Device TC39x
Marking/Step (E)ES-BD, BD
Package see Data Sheet

10291AERRA

This Errata Sheet describes the deviations from the current user documentation.

Figure 2 Message buffer transfer from Message RAM to OBF

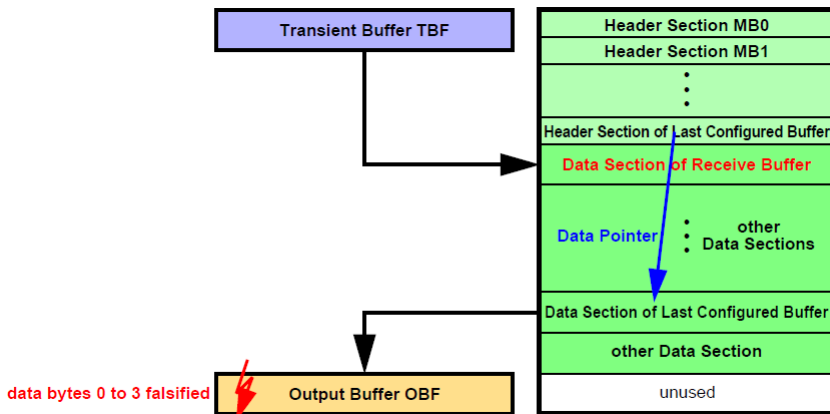
When the message buffer has its payload configured to maximum length (**PLC** = 127), the OBF word on address 00h (payload data bytes 0 to 3) is overwritten with unexpected data at the end of the transfer.

a) When a message is transferred from the Last Configured Buffer in the Message RAM to the OBF and **PLC** = 127 it may happen, that at the end of the transfer the OBF word on address 00h (payload data bytes 0 to 3) is overwritten with unexpected data (see [Figure 2](#)).

Figure 3 Message buffer transfer from IBF to Message RAM

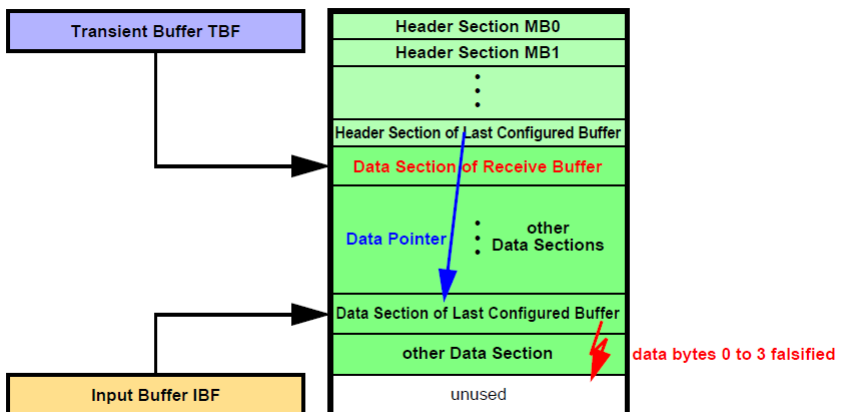
After the Data Section of the selected message buffer in the Message RAM has been written, one additional write access overwrites the following word in the Message RAM which might be the first word of the next Data Section.

b) When a message is transferred from IBF to the Last Configured Buffer in the Message RAM, it may happen, that at the end of the transfer of the Data Section one additional write access overwrites the following word, which may be the first word of another message's Data Section in the Message RAM (see [Figure 3](#)).

Figure 4 Message RAM Configurations

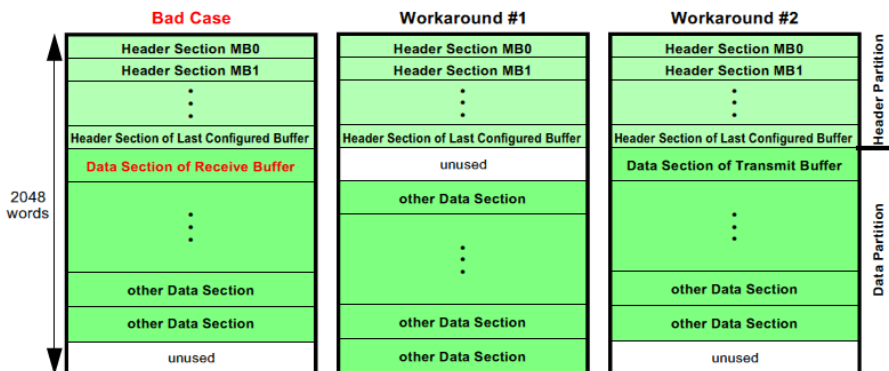
The erratum is limited to the case when (see [Figure 4](#) “Bad Case”):

2) Ensure that the Data Section directly following the Header Partition is assigned to a transmit buffer.

Figure 6 MCS AEI master access path

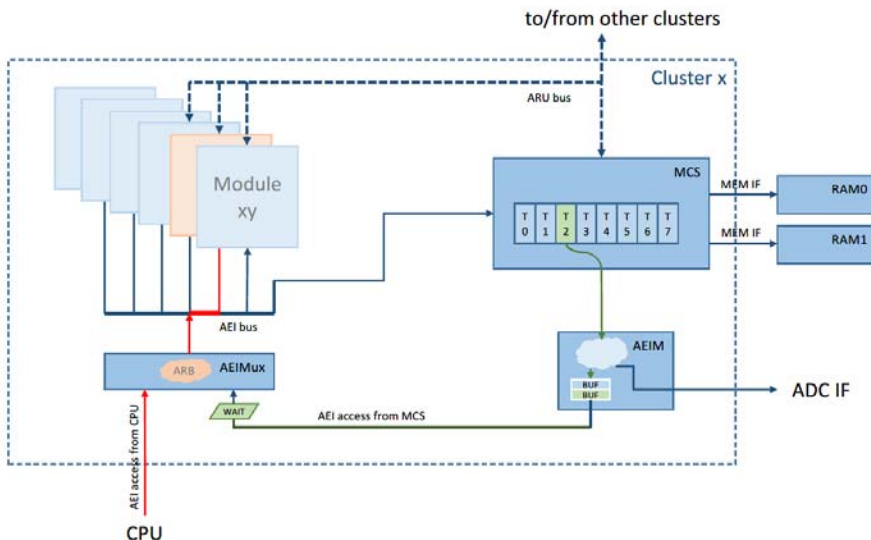
Figure 6 shows an uncritical traffic situation. Here an access of a MCS thread to the AEI bus (green access path) is temporary delayed due to an ongoing AEI bus access from the CPU (red access path). The MCS access to the AEI bus will be safely buffered at the AEIM (green buffer). As soon as the CPU access to the AEI bus completes, the buffered AEI bus access from MCS will be executed.

Figure 7 Critical MCS AEI master scenario

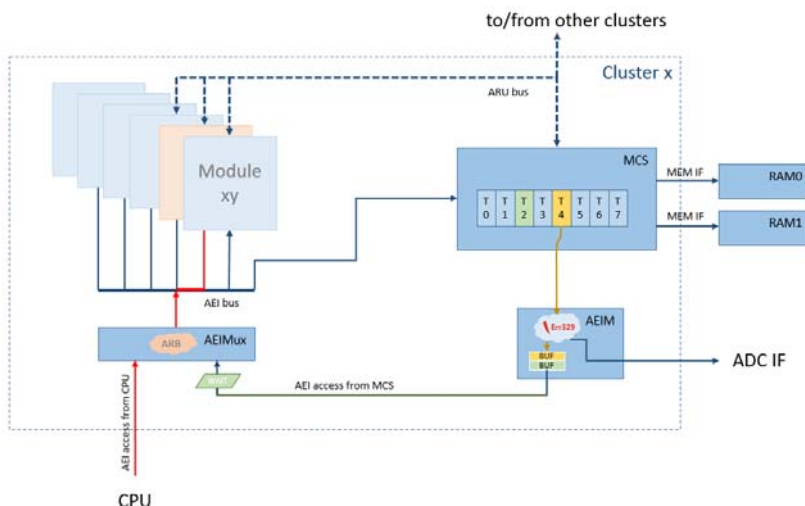
In [Figure 7](#), a potential risk for the occurrence of problem GTM_AI.329 is illustrated. Here the first buffer of the AEIM (green) is still waiting for the access to the AEI bus while a second AEI bus access from MCS arrives at the AEIM (yellow access path). Under certain, but for the user unpredictable timing conditions, this second AEI bus access arriving at the AEIM can trigger the misbehavior described in problem GTM_AI.329.

The workarounds described in the following section will ensure that not more than one AEIM buffer will be filled and therefore the occurrence of problem GTM_AI.329 is avoided. All workarounds have been tested and proven correct.

Figure 8 MCS token mechanism

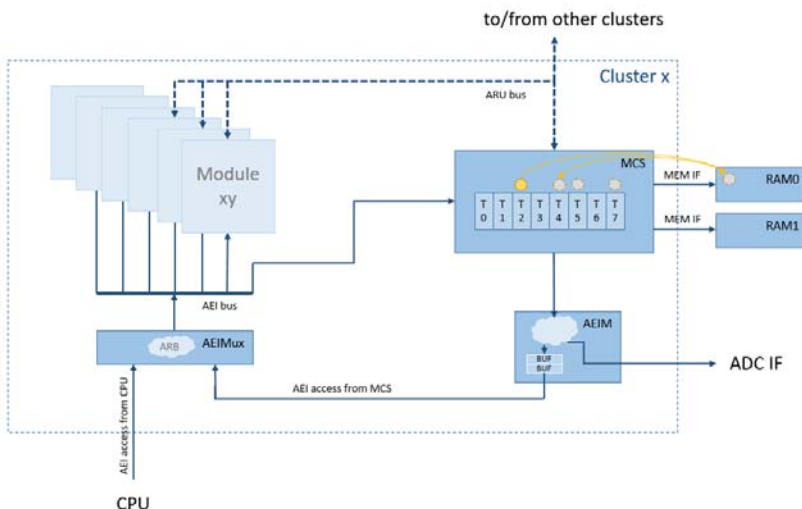
In case multiple MCS channels want to use the AEI master port for AEI or ADC communication, establish a mechanism that ensures that only one channel uses the AEI master at a time (e.g. exchange a token between channels or use trigger registers to hand over the AEI master port ownership between MCS channels).

An application note (AN020 – MCS Mutex implementation) describing a token exchange mechanism between MCS threads is available at Bosch. Such a token mechanism allows multiple MCS threads to safely access the AEI bus system by exchanging an AEI bus access token via MCS memory.

Figure 10 Interrupt Level vs. Pulse-Notify mode - Corner Case Example

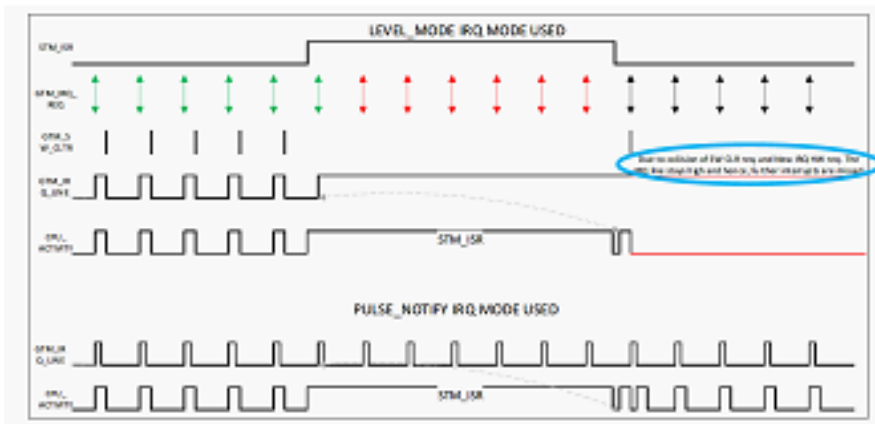
Hence, in Level Mode, in some scenarios where another interrupt request is generated by GTM while the ISR handle also requests a SW clear, then, as the interrupt event is dominant over the clear event (for simultaneous interrupt and clear events), GTM_IRQ_XXX is not cleared and remains high. As a consequence, the IR observes no transition on GTM_IRQ_XX. Thus, any forthcoming interrupt events in this scenario are lost as there is no chance to release the CPU IRQ when a collision happens as shown in Figure below.

If Pulse-Notify mode is selected, every internal trigger will be forwarded to the IR, irrespective of the time of occurrence and the clear event, as the pulse-notify leads to set and reset of GTM_IRQ_XXX as compared to only setting of the GTM_IRQ_XXX line in Level mode.

Figure 12 Timing of LVDS TX interface command sending in relation to IRQ.IFCFS

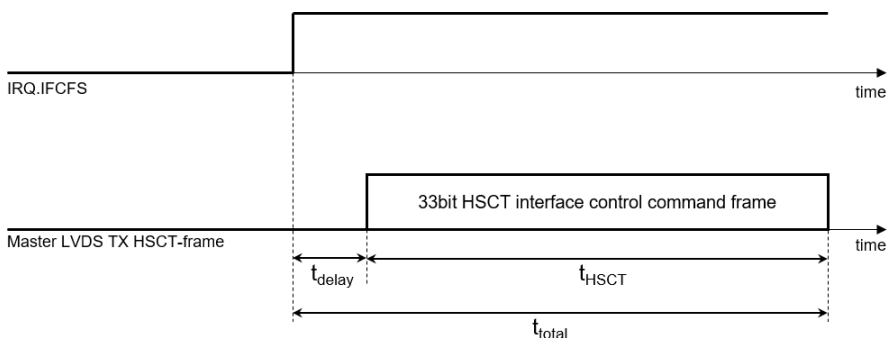
the user might falsely assume that also the actual sending on the LVDS TX port has already occurred once the IRQ.IFCFS flag is set, which is not true.

Instead the timing shown in **Figure 12** applies.

Figure 13 ADC Trigger Concept

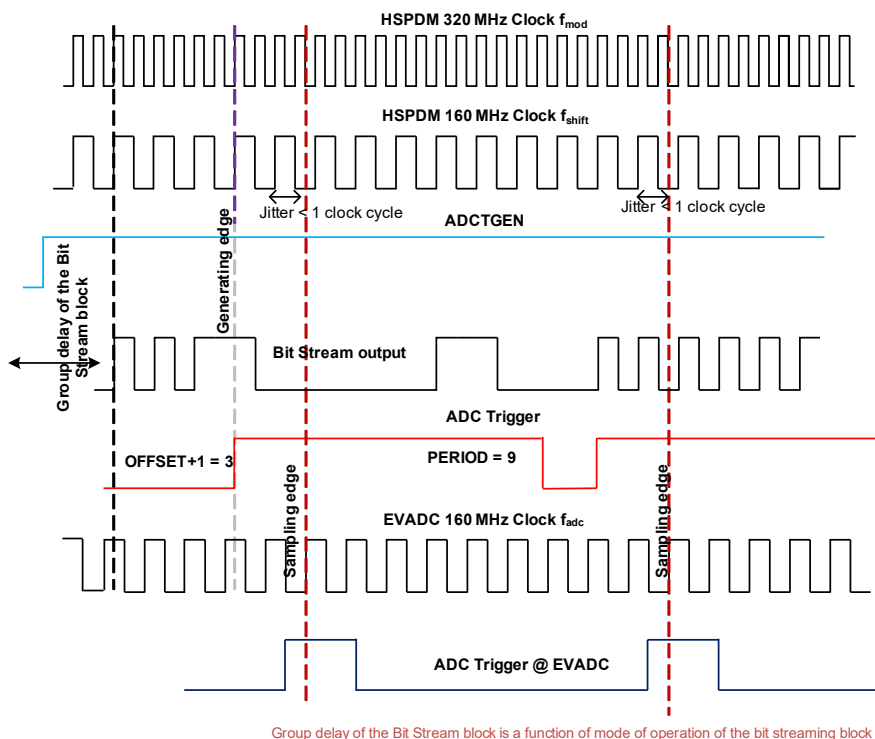
HSPDM_TC.H004 ADC Trigger Concept - Figure update

Figure “ADC Trigger Concept” in the current version of the HSPDM chapter of the TC3xx User’s Manual shall be replaced with the following updated figure:

Figure 14 SDIO Card Interrupt Sequence

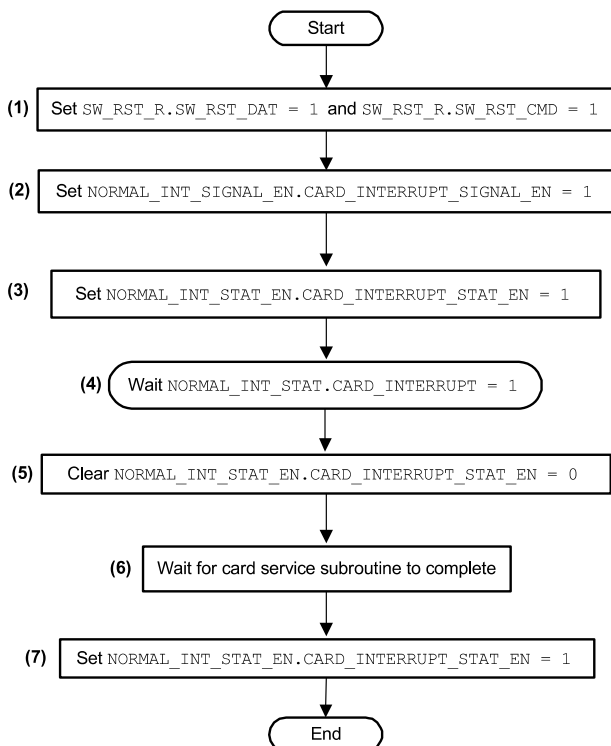
SDMMC_TC.H002 SDIO Card Interrupt Sequence - Figure update

Figure “SDIO Card Interrupt Sequence” in the SDMMC chapter of the current version of the TC3xx User’s Manual is wrong. The correct sequence is shown in the following **Figure 14**.
